INNER WEST COUNCIL

DEVELOPMENT ASSESSMENT REPORT

Application No.	D/2018/474
Address	103 Birchgrove Road, BIRCHGROVE NSW 2041
Proposal	Alterations and additions to a semi detached cottage.
Date of Lodgement	7 September 2018
Applicant	L Mitchell
Owner	Ms L J Mitchell
Number of Submissions	Three
Value of works	\$226,000
Reason for determination at Planning Panel	Clause 4.6 variation exceeds officer delegation
Main Issues	Heritage Glazed balustrade around roof
Recommendation	Approval
Attachment A	Recommended conditions of consent
Attachment B	Plans of proposed development
Attachment C	Clause 4.6 Exception to Development Standards
Attachment D	Statement of Heritage Significance for Iron Cove heritage conservation area
Attachment E	Arborist Report

Figure 3: Shadow diagrams as marked up in submission

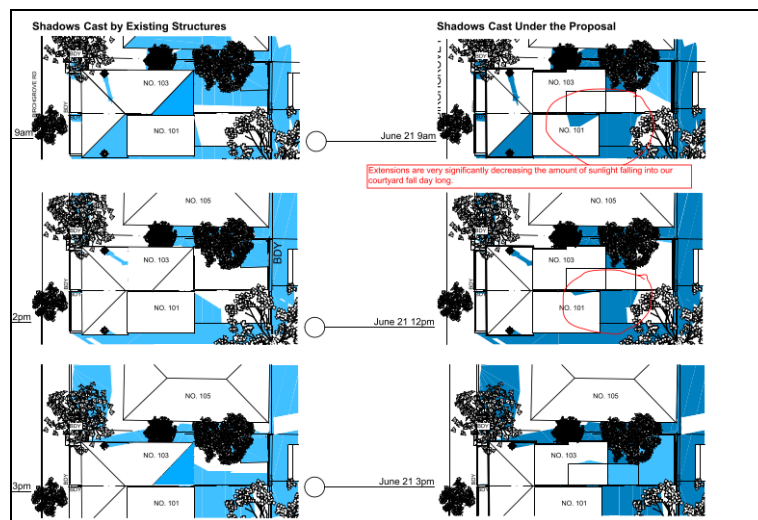
Issue: Overshadowing to property and courtyard at 101 Birchgrove Road.

Comment: The submitted shadow diagrams indicate that the courtyard of 101 Birchgrove Road is currently overshadowed throughout the day in winter and this will not be altered by the proposal. The area affected by additional overshadowed from the proposal indicated in red on the submission is not the courtyard at 101 Birchgrove Road but the roof of the kitchen/bathroom as indicated in real estate brochures from late 2016.

elevations sheet 1 of 2

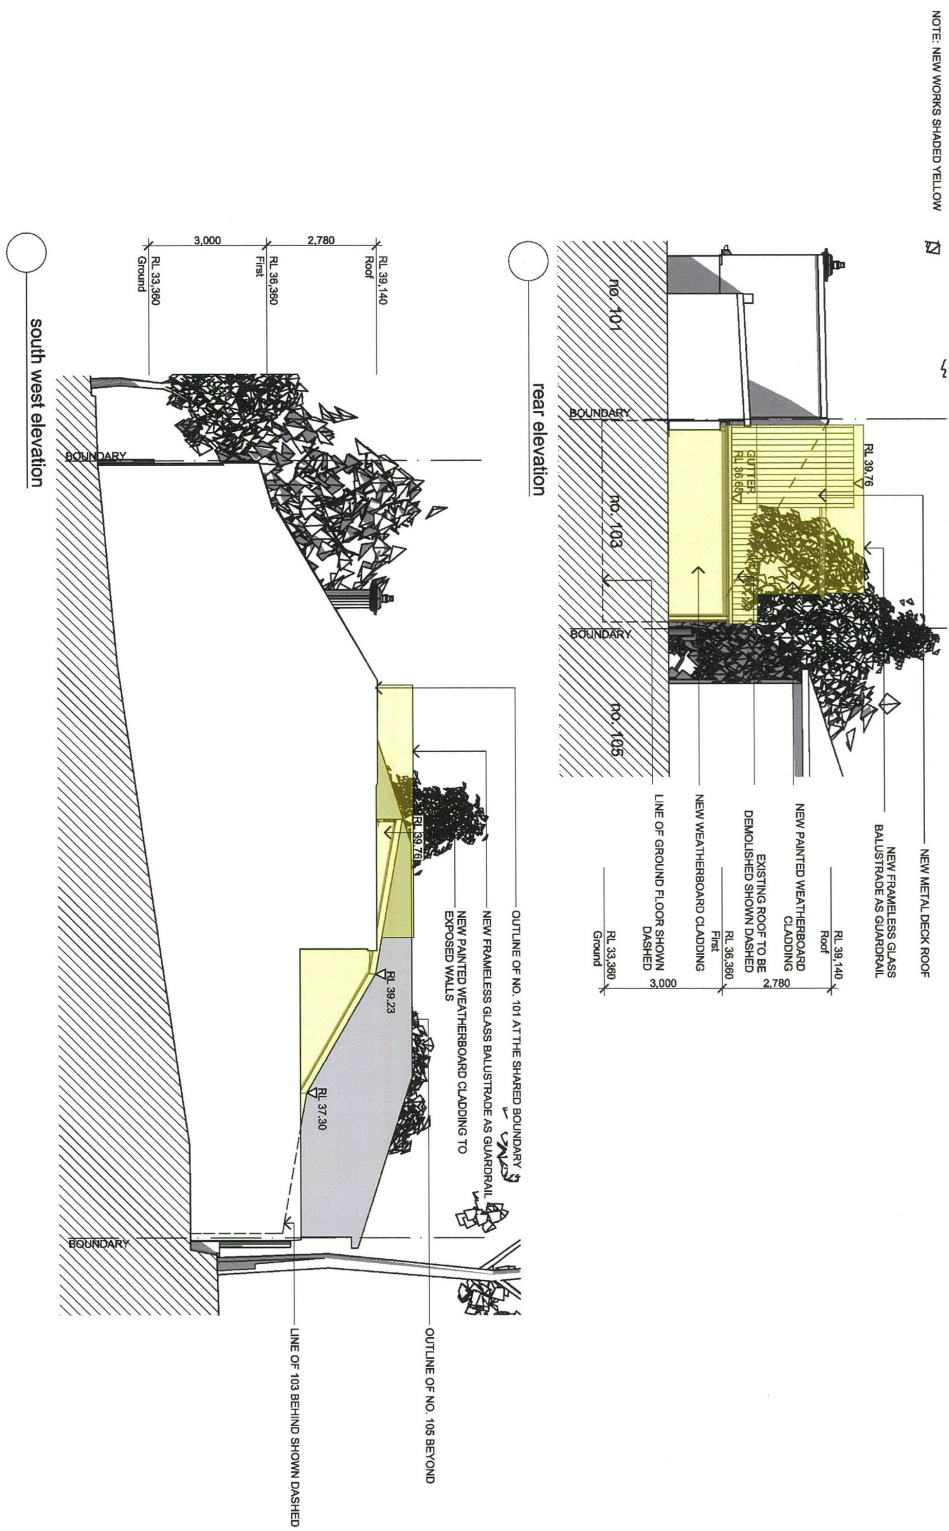
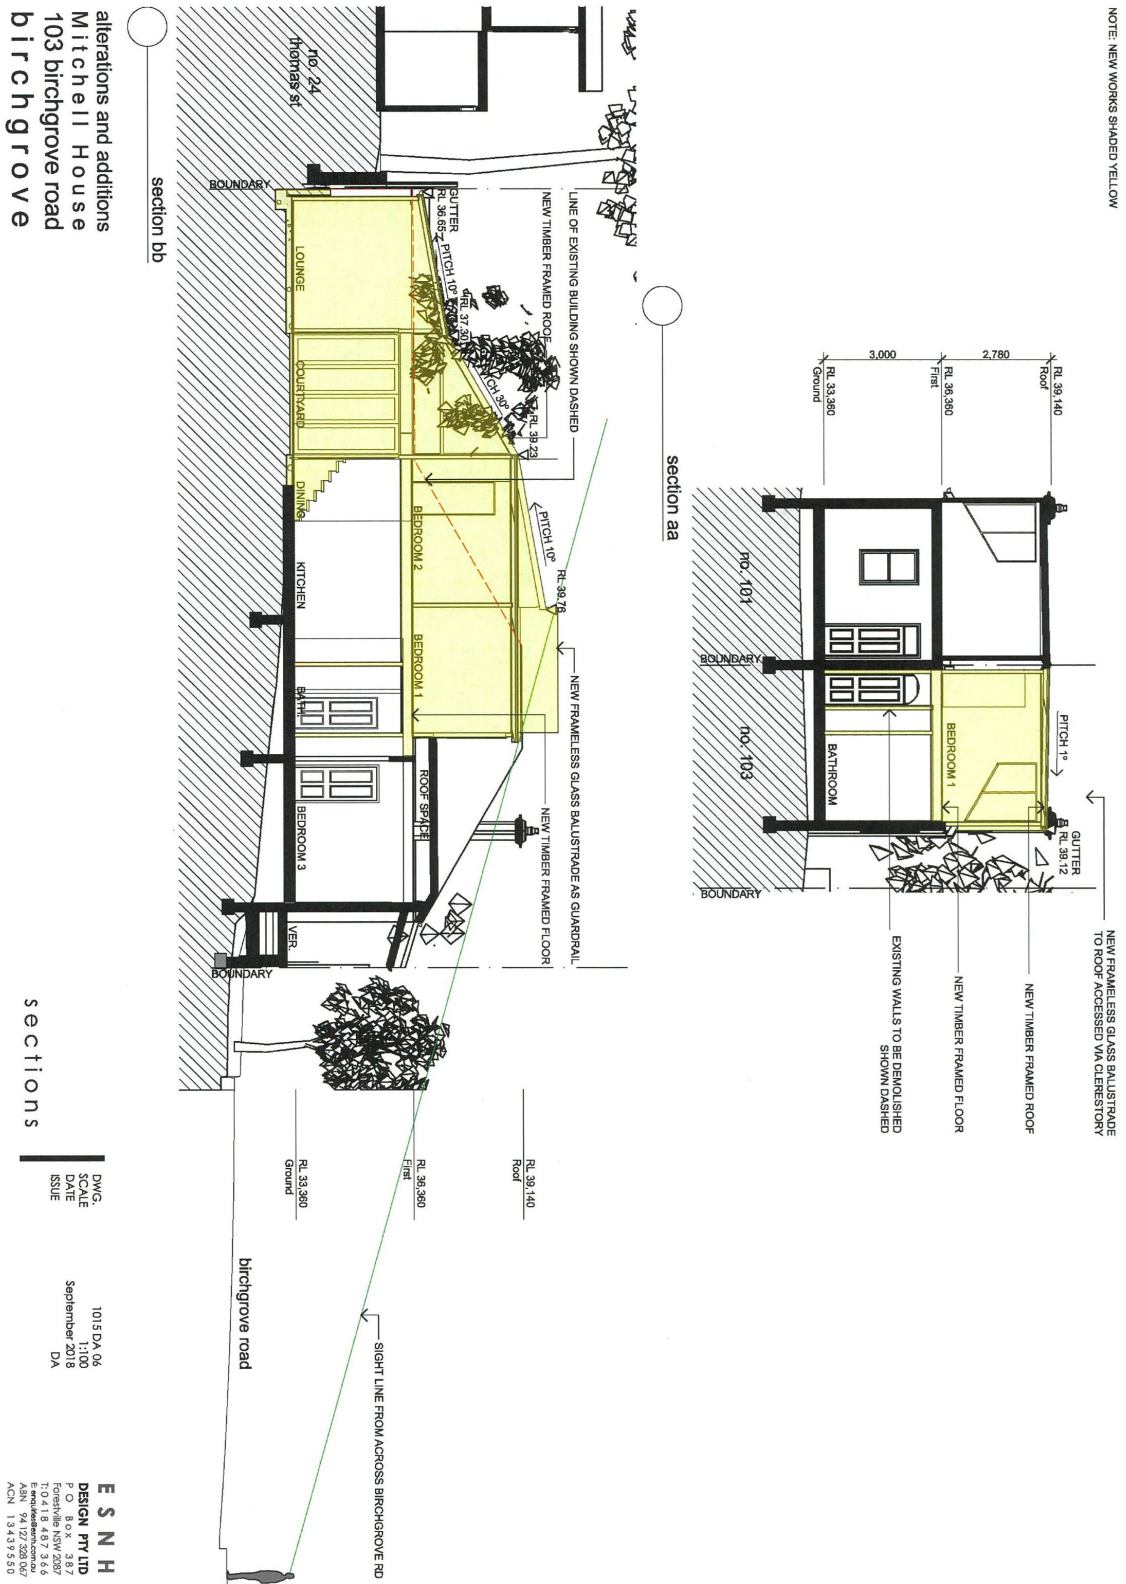
The proposal is against good heritage practice and is contrary to Leichhardt Development Control Plan 2013 as it would remove the rear roof plane of the main roof of a contributory item.

Comment: The applicant has advised *the proposal includes a guard rail for the perimeter of the roof over the first floor as a safety measure when carrying out maintenance work at this level.* The objector rightly points out that “if such a “safety measure” is needed for maintenance, there would be guardrails on most Balmain properties, including mine.” The proposed balustrade is opposed from a heritage perspective and on planning grounds.

- X. Amended plans are to be submitted incorporating the following amendments:
- The first floor must not exceed the height of the first floor on the adjoining dwelling at 101 Birchgrove Road, Birchgrove. The proposed glazed balustrading and clerestory window should be deleted.
